15-23-01 - Head Gasket Leakage

Technical Service Bulletin

Transaction No: 2071245/1

Figure 1.

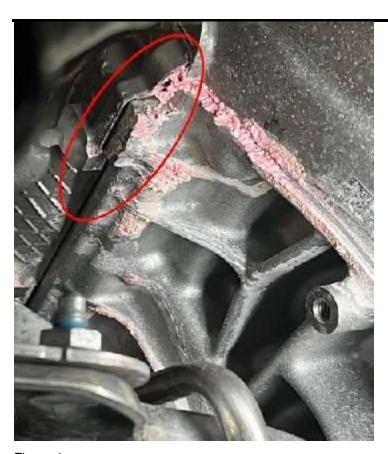
If a coolant leak is found between the cylinder head and engine block, at the back of the engine below the turbo as indicated in Figure 1. and Figure 2., the head gasket must be replaced per Elsa Pro instructions.
